MEMORANDUM

SUBJECT: Staff Analysis for the North Lake Recreational Sewer & Water District Wastewater Reuse Permit Application, LA-000070-03 (Municipal Wastewater)

PROJECT NO. 105050	
FILENAME Meridian, Idaho 83642	
Land App. 11-8.dwg	
KELLER ASSOCIATES	
131 SW 5th Avenue, Suite A Meridian, Idaho 83642 (208) 288-1992	
North Lake Recreational Sewer & Water District	
WLAP Application	FIGURE NO.
Facility Site Map (Part A)	3 rev

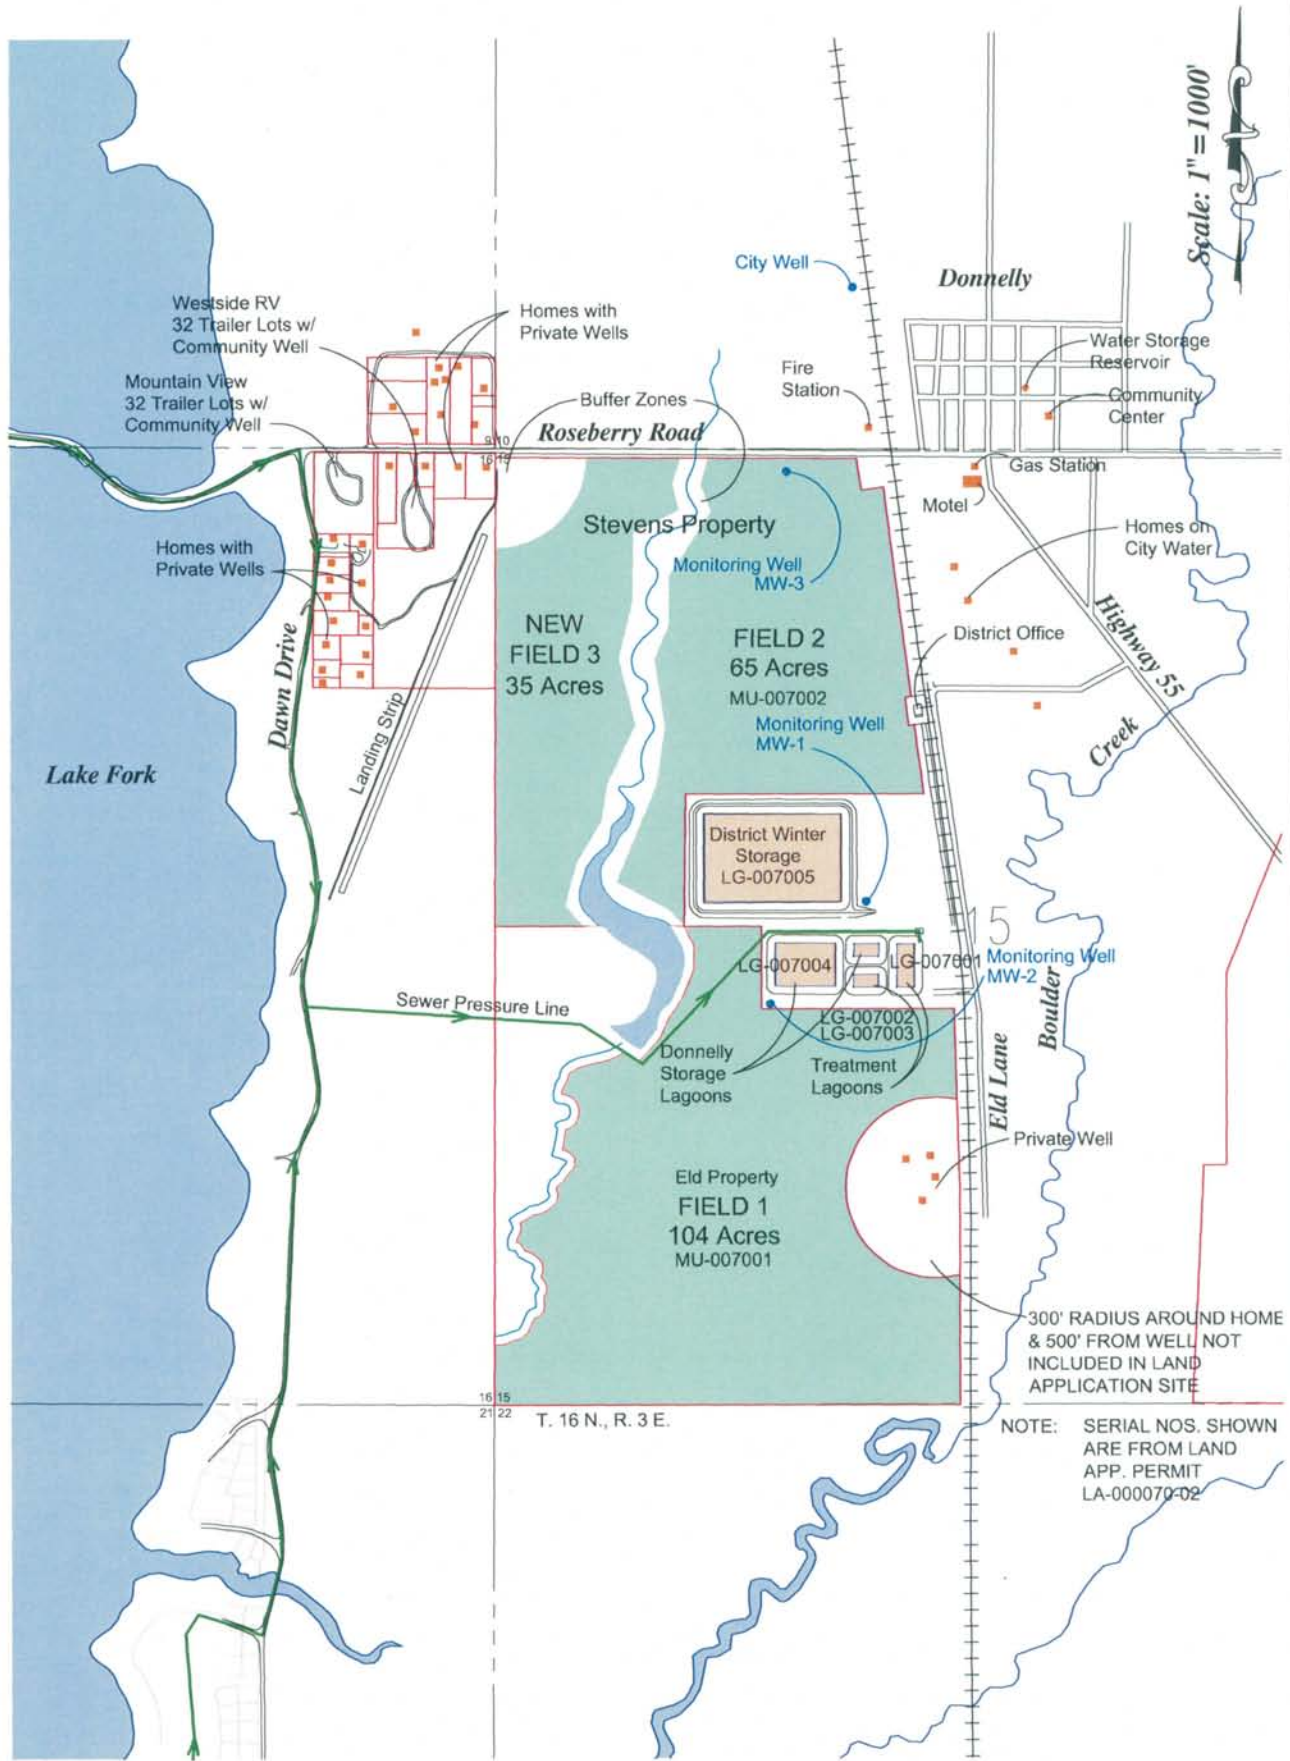
bacteria. The shallow ground water is not used for any potable purposes and Figure 3, *Facility Site Map, Part A* (Application 2006) shows there no private wells near the southern boundary of the slow rate fields. The current permit requires ground water sampling in April and October. Staff recommends the sampling frequency remain the same for the slow rate sites.

PROJECT NO. 105050 131 SW 5th Avenue, Suite 4 Meridian, Idaho 83642 (208) 288-1992 FILENAME 105050WellLoc.dwg
	North Lake Recreational Sewer & Water District
WLAP Application Well Location Map	FIGURE NO. 5

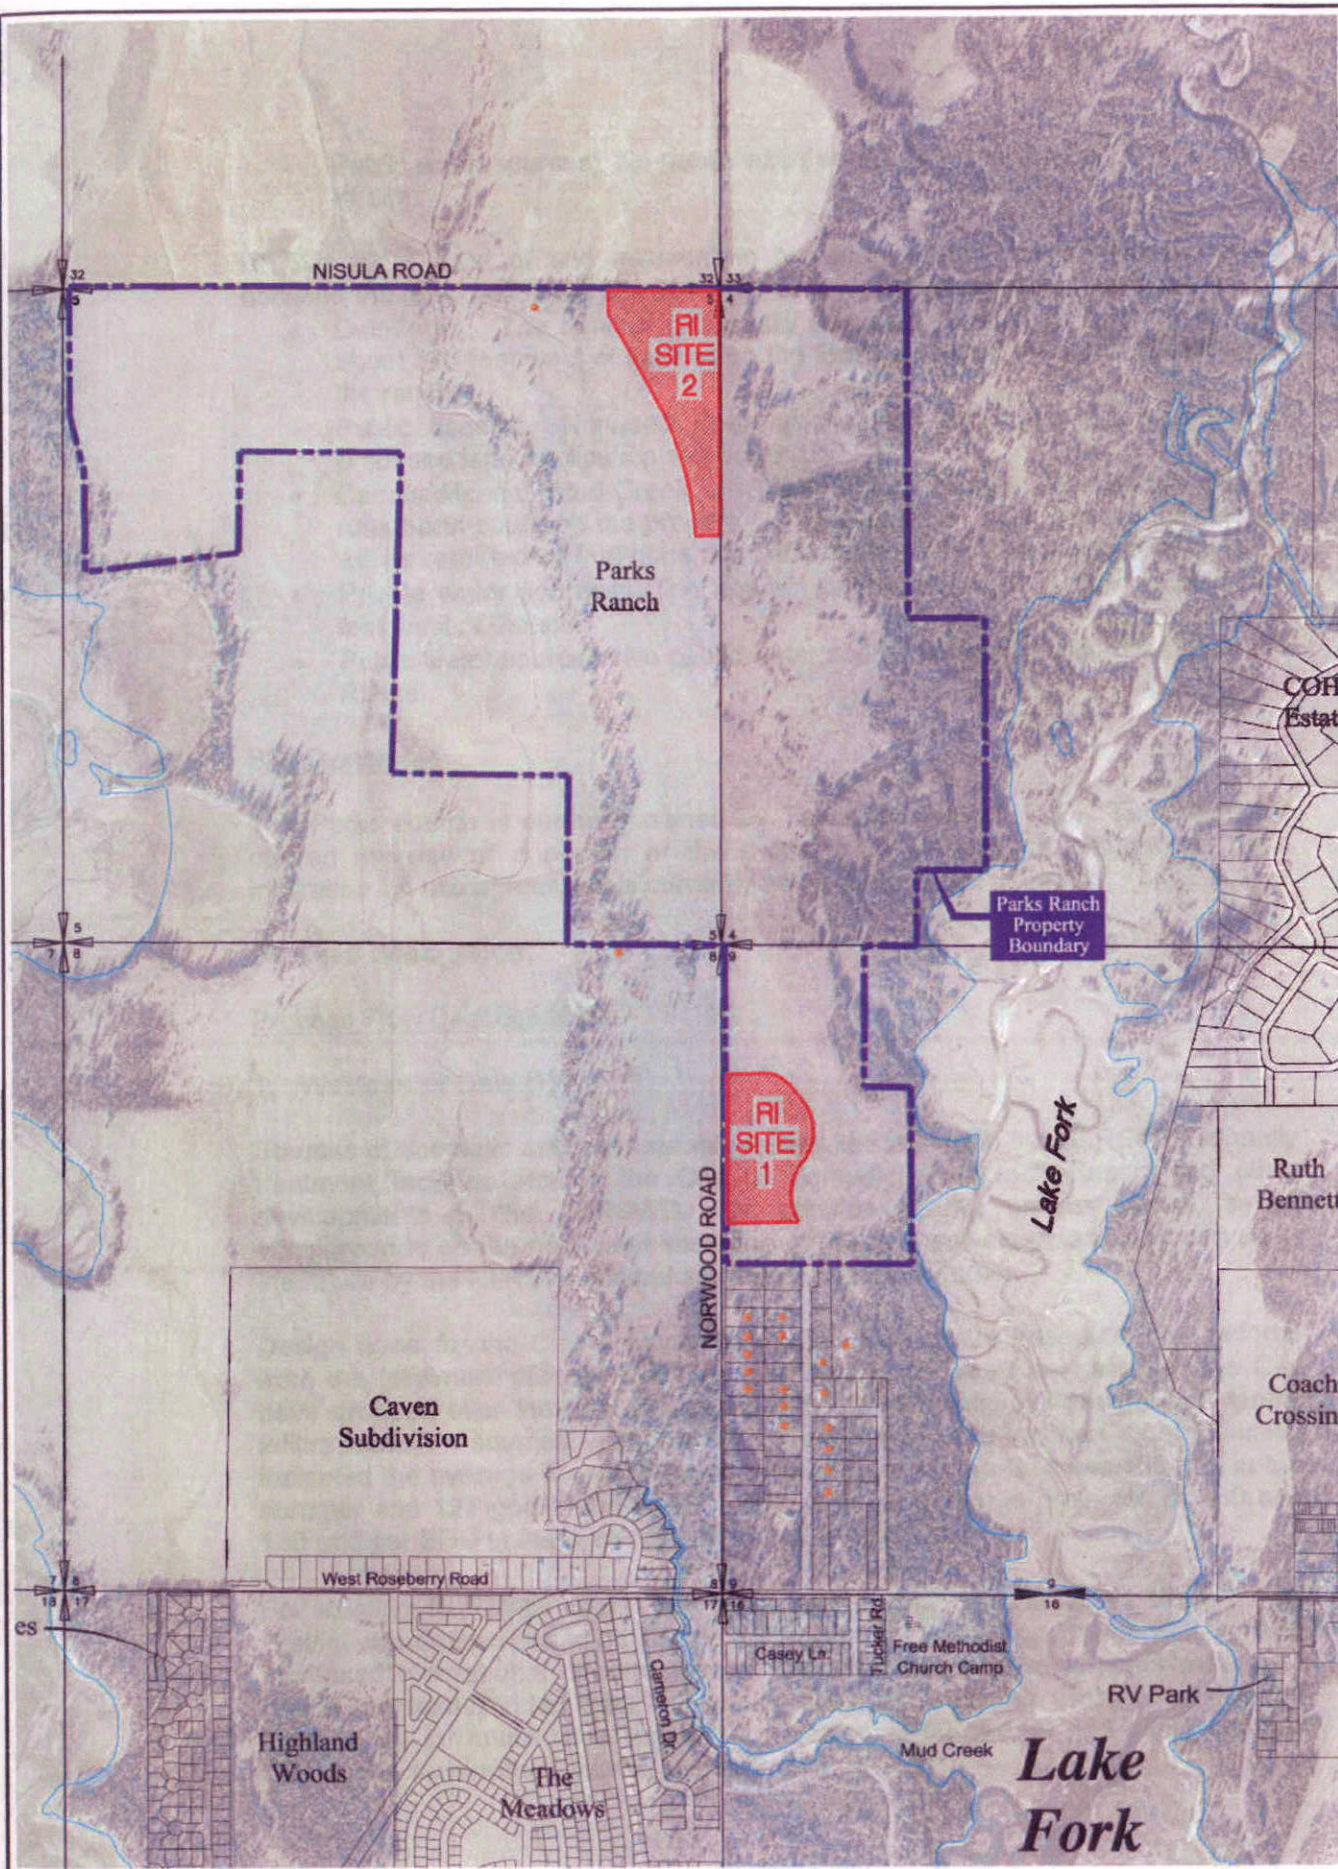
Figure 4, Facility Site Map, Part B (Application 2006) shows the two RI sites. **Figure 5, Well Location Map** (Application 2006) shows the homes with private wells located in the vicinity of the RI sites.
